DS-K1T331 Series MinMoe Terminal Release Notes (2021-11-15)

Device Model: DS-K1T331 DS-K1T331W	Firmware Version	ACS_331_AI2_EN_STD_V3.2.30_build211110 ACS_331_AI2_EN_NEU_V3.2.30_build211110
	SDK	Latest baseline
Naming Rule: W for WIFI	iVMS-4200 Client Version	Latest baseline

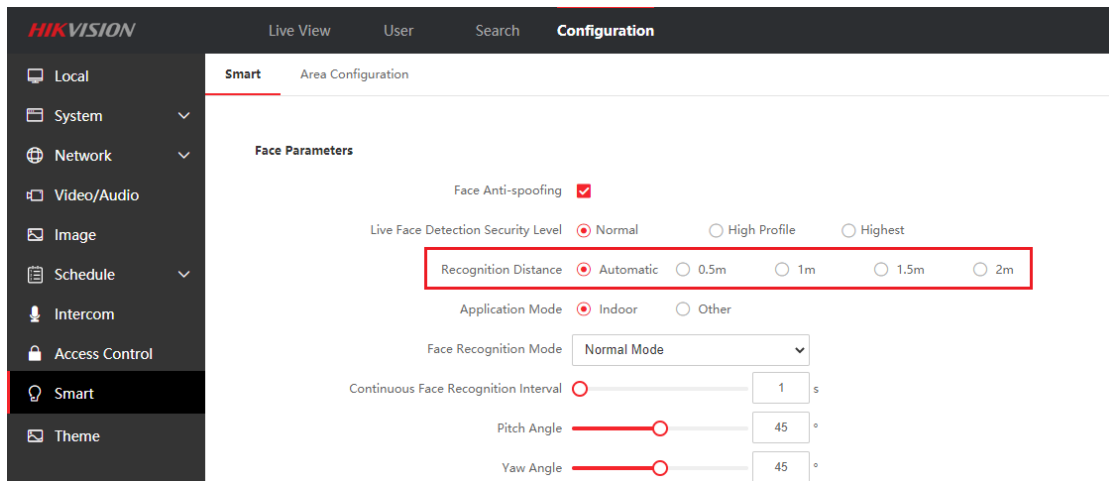
1. Add Hik-Connect menu in device UI Menu → Comm. The function is disabled in default.

1. Optimize the wake-up distance of the device screen through the face, and the wake-up distance is consistent with the recognition distance
